PCN

Reduction of the contact windows within the bond areas for C38 pressure sensors

201127THERM1e

Enclosure PCN (ID No. TPS T125/01)

Picture: Change of contact and bond area

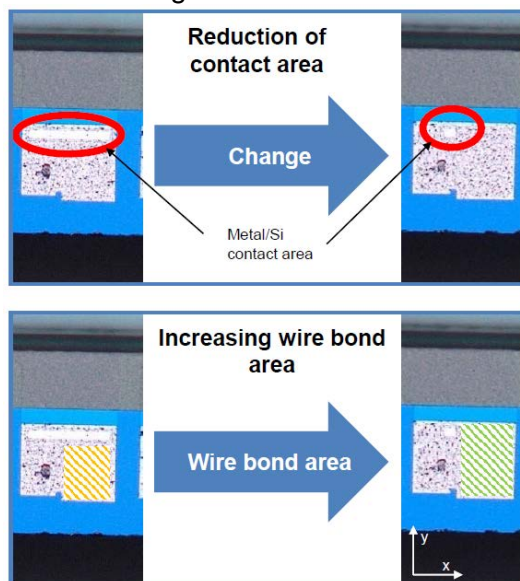
The bond areas of EPCOS C38 pressure sensor elements are divided into a wire bond area for contacting and a contact window that establishes the electrical connection to the piezoresistive resistors. To make the pressure sensor element even more robust against potential influences of subsequent processing steps in the customer application, these contact windows within the bond areas will be significantly reduced in the future. Since the total area of the bond pad is unchanged, an increased wire bond area will be available for our customers in future. This means that the C38 pressure sensor element can still be contacted using the familiar parameters, or the additional area can also be used. The reduced contact windows are already being used in other EPCOS pressure sensor elements such as C33 or C39 for the automotive sector.

The external shape or position of the bond areas are not changed.

4. Description of change C38: Reduction of contact area within bond pad			
5. Effect on the product or for the customer (benefit, quality, specification, lead time) Reduction of contact area within each bond pad. No change on size or position of any bond pad. No change of any material or process flow.
